**From:** Bohlen, Steve@DOC <Steve.Bohlen@conservation.ca.gov>  
**Sent time:** 07/30/2020 05:39:30 PM  
**To:** Mindy.Nguyen@lacity.org  
**Subject:** CGS Comments on proposed Hollywood Center DEIR  
**Attachments:** CGS Comments on Hollywood Center Project DEIR FINAL 20200716.pdf

**SUBJECT: Comments on the April 16, 2020 Draft Environmental Impact Report for proposed “Hollywood Center” project. State Clearinghouse Number SCH 2018051002.**

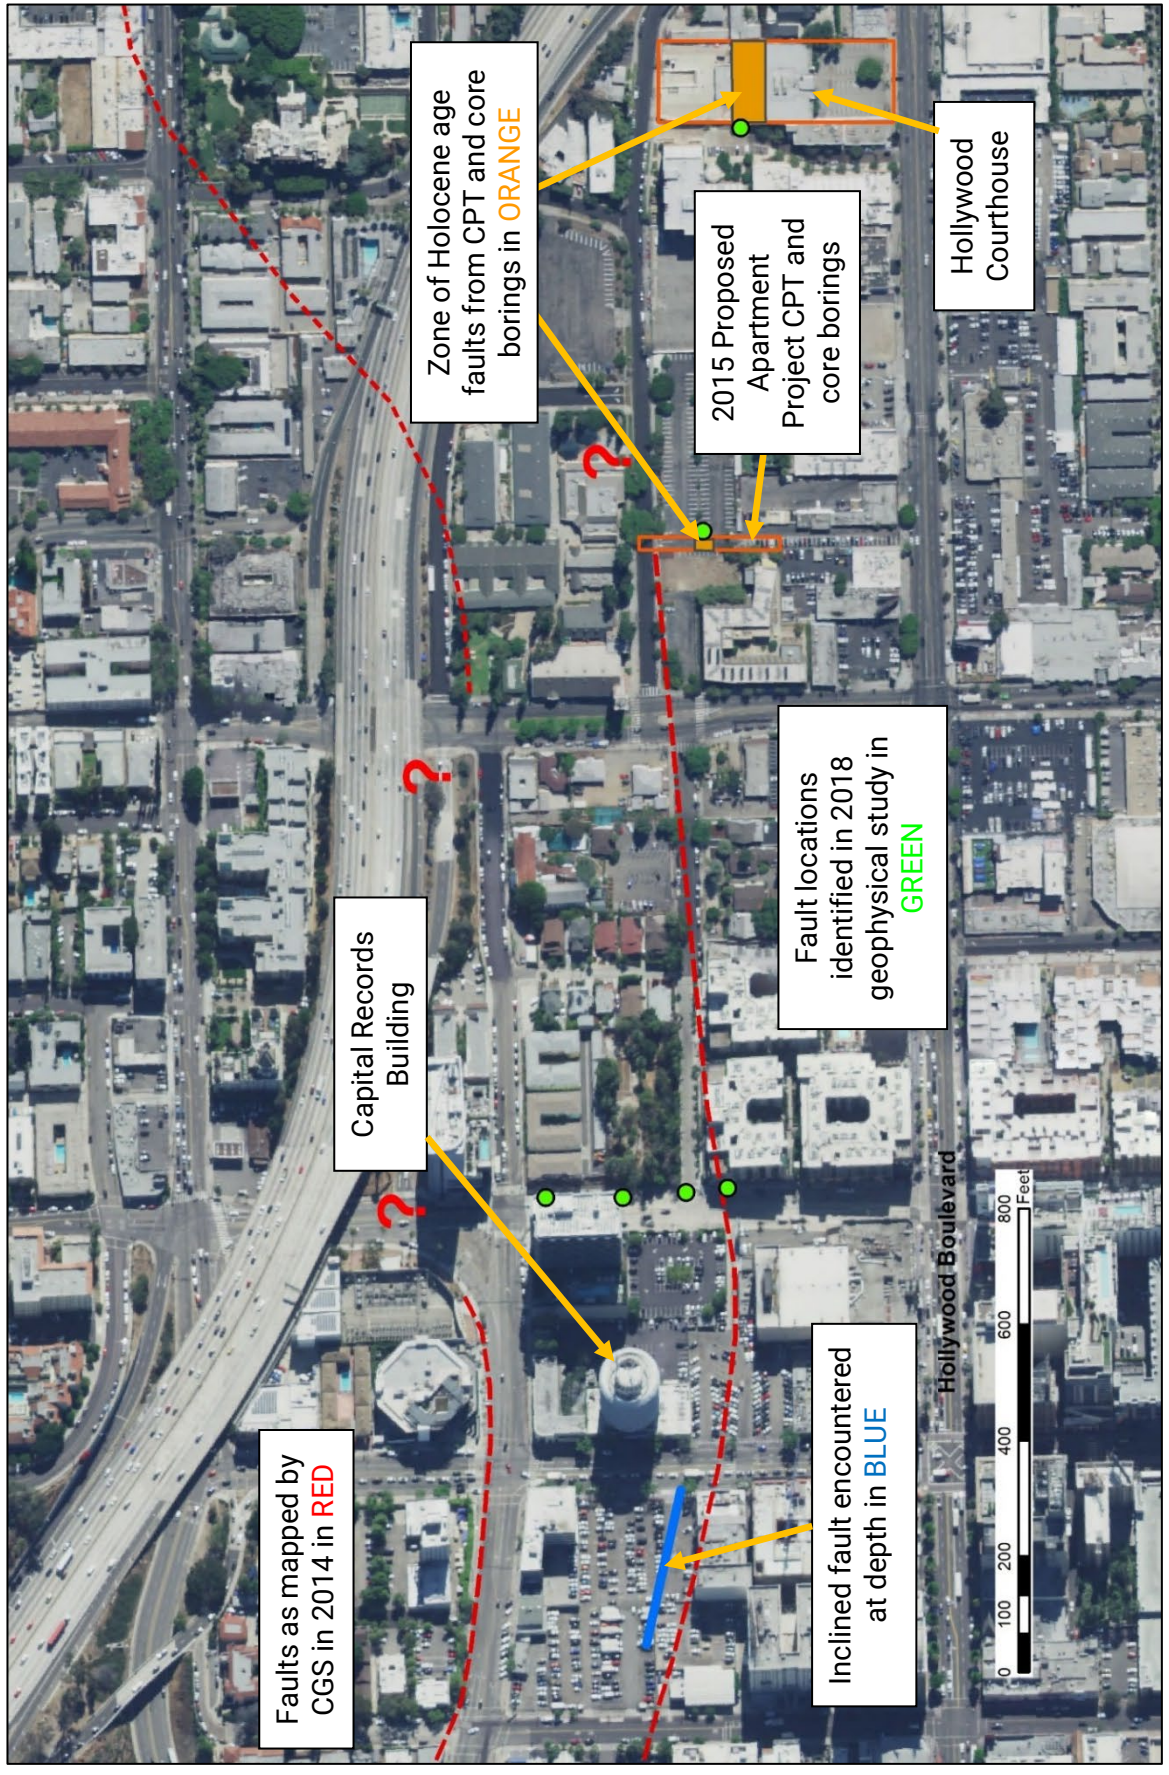
- 1. Fault traces depicted in CGS's 2014 Hollywood Fault Map do not appear in Appendix G-1's figures of the project site** where locations of their subsurface investigations are presented. Therefore, we attach a figure showing both the location of traces as shown on the 2014 Hollywood Fault Map and the areas of investigation reported in Appendix G-1 (**Figure 1**). (DEIR Appendix G-2 shows the location of the fault trace at a lower level of resolution.) We note below that Figure 1 reflects new information indicating the active fault, which was not cleared by either the 2014 trench or the other investigative techniques reflected in Appendix G-1.

- 2. The 2020 USGS study, and other studies that post-date CGS's 2014 Hollywood Fault Map, strongly suggest an active strand of the fault crosses the project site.** CGS considered the 2020 USGS study in light of other studies conducted after the 2014 Hollywood Fault Map. These studies are listed at the end of this letter and, for your convenience, are also available on CGS' FTP server ([FTP Link](#)). These studies, conducted east of the project site, postdate the studies included as Appendix G-1 to the DEIR, and are therefore new information of importance to public safety. These studies strongly support the presence of an active southern fault strand entering the eastern Hollywood Center property in the vicinity of the alley at Argyle, south of the

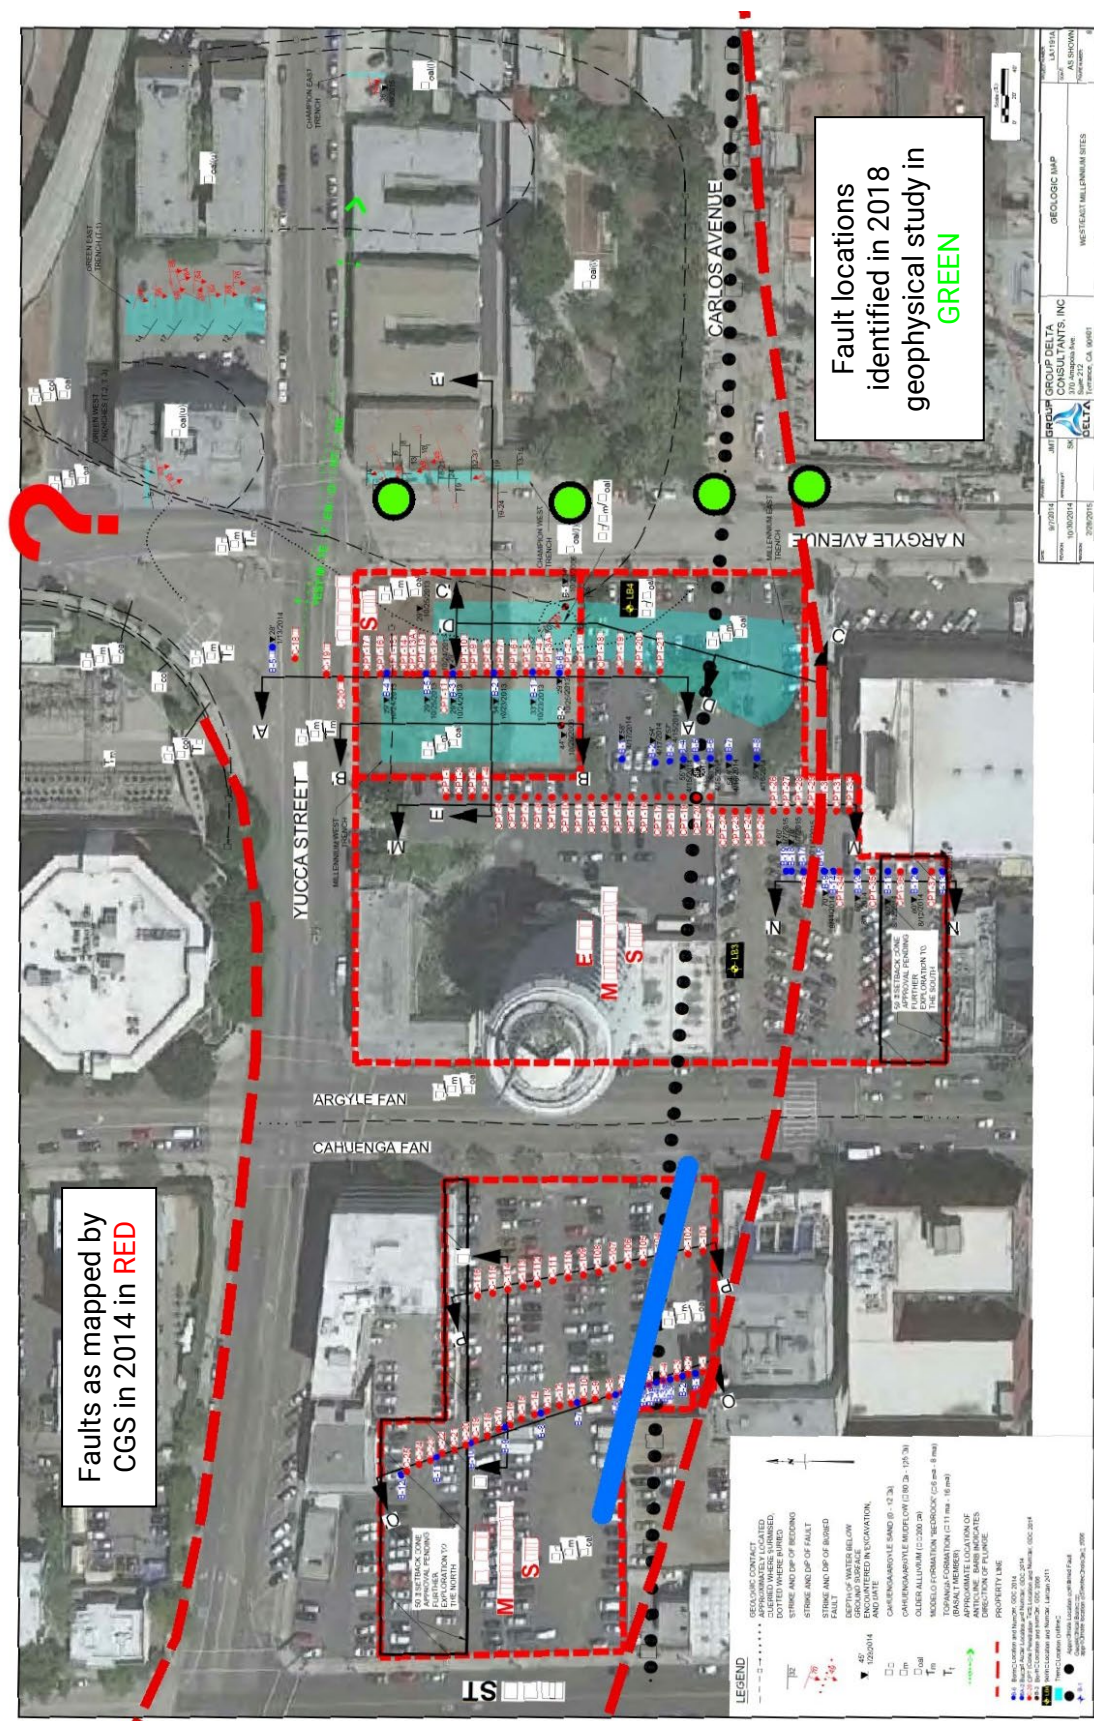
3. **The fault trench excavated in 2014 did not clear the entire site of active faults.** Based upon review of the information presented in Appendix G-1 of the DEIR, the GDC trench on the east property did not completely expose the base of the Holocene-age geologic section across the north-south extent of the site and therefore cannot be considered to exclude the presence of an active fault at or near where it is depicted in CGS's 2014 Hollywood Fault Map, or in the more recent studies mentioned above.

4. **Other fault investigation techniques used on the site are not definitive in clearing the site of active faults.** Based on review of the information presented in Appendix G-1 of the DEIR, the fault studies prepared for the proposed Hollywood Center Project, both east and west properties, primarily rely upon subsurface investigations conducted by Cone Penetration Testing (CPT) and small-diameter boreholes. While these types of investigations can provide beneficial information, they are subject to ambiguous interpretations, particularly regarding the activity of faulting because geologists cannot clearly see which stratigraphic horizons are cut by a fault. A third-party review of the geologic studies conducted for the Hollywood Center Project (see Earth Consultants International, Project No. 3425, June 3, 2015; [FTP Link](#)), which was not included in Appendix G-1 of the DEIR, acknowledges the limitations of the project CPT and borehole subsurface investigations, including unresolvable errors in the re-survey efforts of these data locations. The third-party review also presents multiple possible interpretations of the locations and activity of the faults under the site (ECI, 2015, Plate 4), including an interpretation showing the distinct possibility that the southern strand of the Hollywood Fault is active beneath the project site (ECI, 2015, Plate 4, Interpretation A). CGS understands the project proponents report the project site is underlain by older stratigraphy, capped by Holocene age deposits (<11,700 years old). In their interpretation of boreholes and CPT's, they have postulated the faulting they have identified does not extend into the Holocene units. CGS' interpretation of the CPT and borehole data finds the fault can be drawn to extend into the Holocene units, such as Scenario A in the ECI report. These differing interpretations of fault activity along the southern strand are because only
